From: [REDACTED]
Sent: 27 April 2016 15:16
To: [REDACTED]
Cc: [REDACTED]
Subject: 270216 1516 RE: Brook Green Braintree
Attachments: TN02_Land_at Fitch Way Rayne TN_Response_Review_Issued.pdf

Project:	Highways England Spatial Planning Arrangement	Job No:	60343567 DX077.002
Subject:	Land at Flitch Way, Rayne Response Review		
Prepared by:	████████████████████	Date:	20th April 2016
Checked by:	██████████	Date:	21st April 2016
Verified & Approved by:	████████████████	Date:	25th April 2016

- 1.1. This Technical Note (TN02) has been prepared by AECOM on behalf of Highways England (HE) to document a review of a follow up Technical Note Response (TNR) associated with a proposed development at the Land at Flitch Way, Rayne (LaFW), Braintree. The TNR has been prepared by Journey Transport Planning (JTP) on behalf of the developers, Acorn Group Braintree Ltd (AGB).

Figure 12
Reassigned Local Traffic (AM Peak 0800-0900hrs)

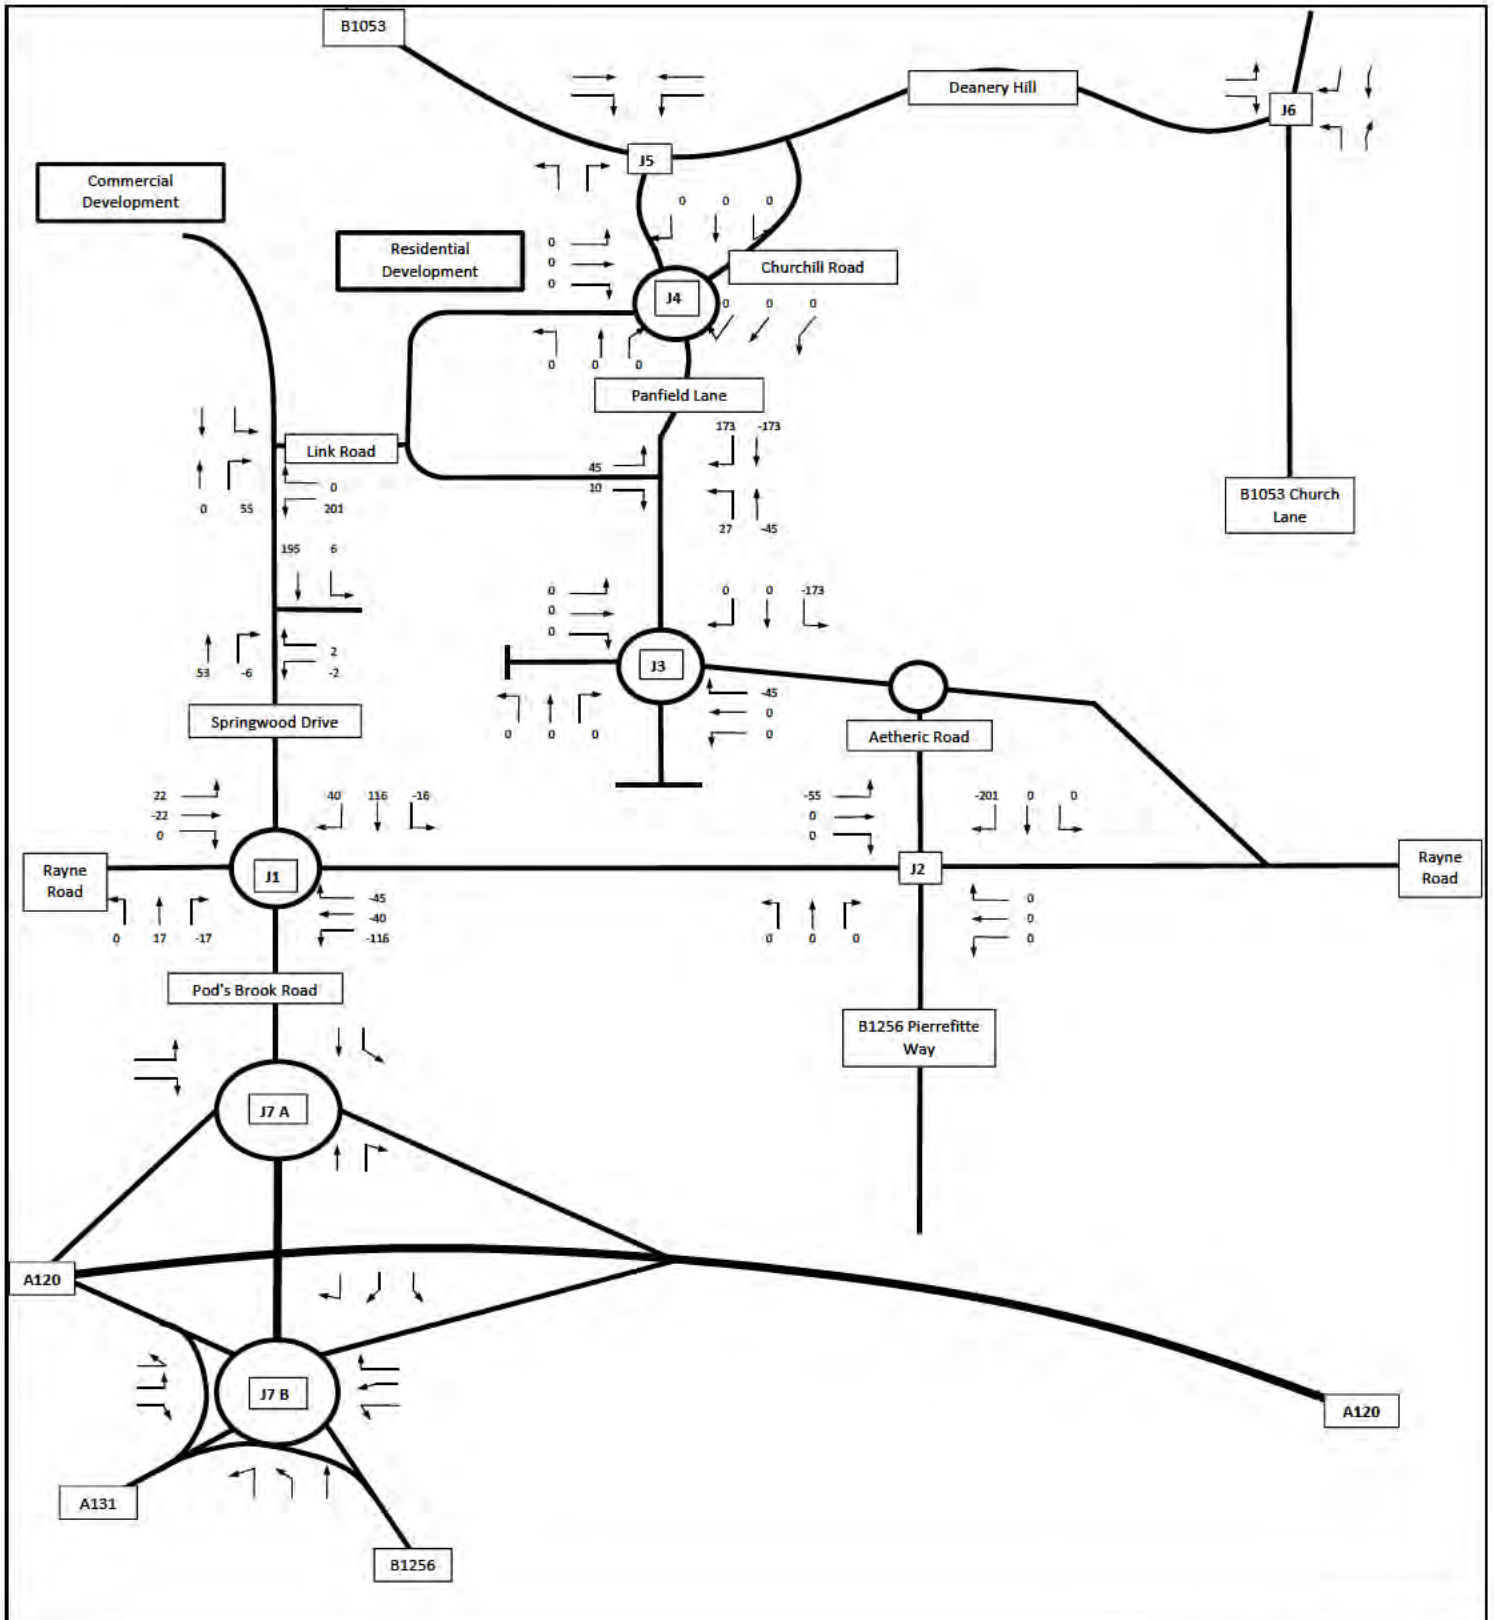
In Figures 7 and 9 – I was expecting these flows to add up to flows in Figure 18 in Appendix 6. For example, I was expecting the total AM peak re-assignment to be -71 for the right turn from Rayne Rd into Springwood Drive.

Can you explain where the -168 stems from (Figure 7)?

I have also referred to the most recent TA for the Panfield Lane development, carried out by Vectos and submitted with their planning application to Braintree District Council to try and match these flows. This TA is in the public domain and includes re-assignment traffic flow diagrams (see attached). I was also unable to match Figures 7 – 10 with these flows.

Figure 1: 2015 AM Traffic Flows at the A120 / Pod's Brook Road / A131 (North) Roundabout

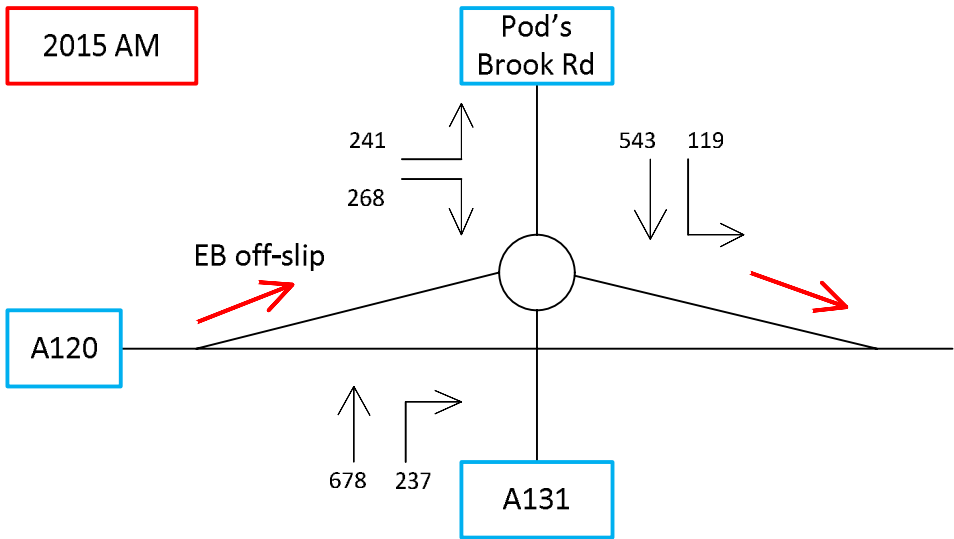
- 5.8. In order to try and understand this further, AECOM have analysed the 2015 base traffic flow data for the roundabout. The AM and PM peak traffic flow diagrams (Figures 1 and 2 from JTP's TNR2) have been replicated in Figures 1 and 2.

5.9. Figures 1 and 2 demonstrate that in the AM peak, the A120 approach traffic is quite balanced between left and right turners, however in the PM peak the number of right turners is significantly higher. In both peaks the A131 approach traffic has a dominant south to north movement from the A131 to Pod's Brook Road. It should be noted that the A131 approach traffic does not have to give-way to any circulating traffic (other than u-turners) which is likely to result in this traffic entering the roundabout at speed. Visibility to the right for vehicles giving way at the A120 approach arm is limited due to the presence of the bridge over the A120 (refer to Figure 3).

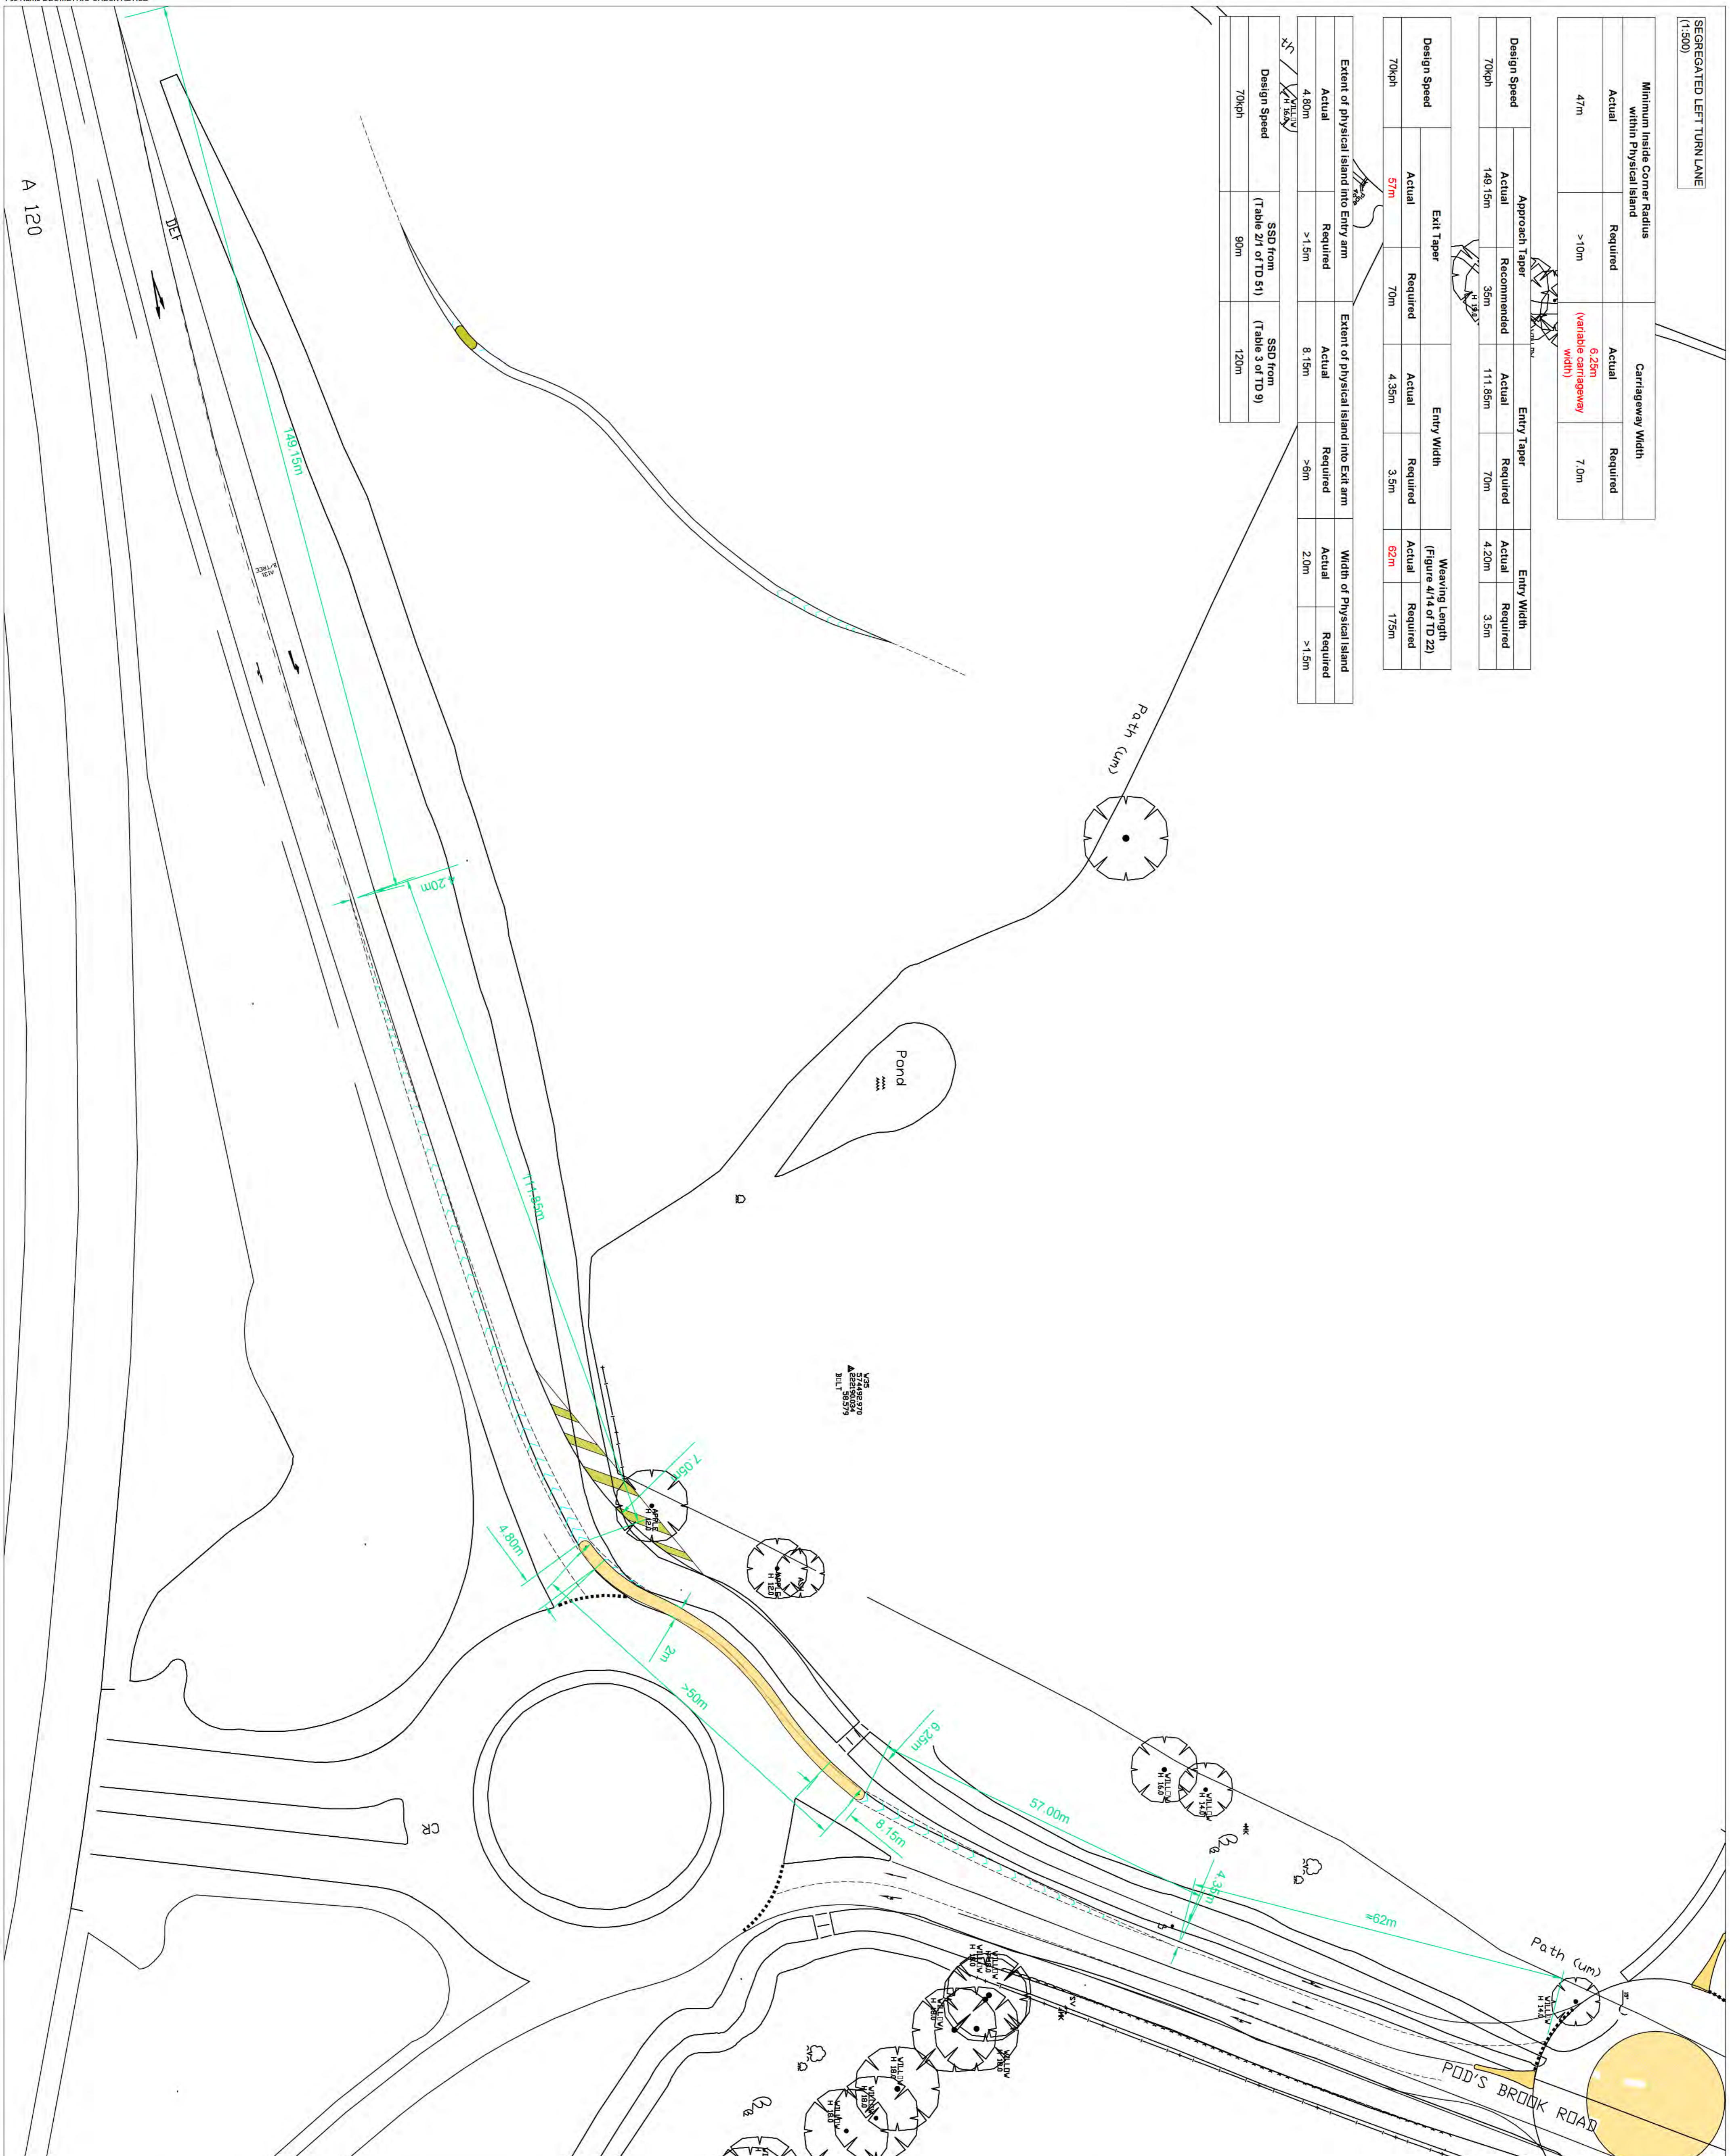
- 3.4. This Technical Note will firstly review the compliance of the updated layout shown on drawing DR10 with TD 16/07. The following comments have been observed.

4.6. AECOM have reviewed the geometric parameters entered into the proposed layout ARCADY model to ensure they are representative of the layout presented in drawing DR10. AECOM found discrepancies with the geometric parameters. The differences between JTP and AECOM's geometry measurements of the roundabout are shown in Table 5, with AECOM's measurements in red text.
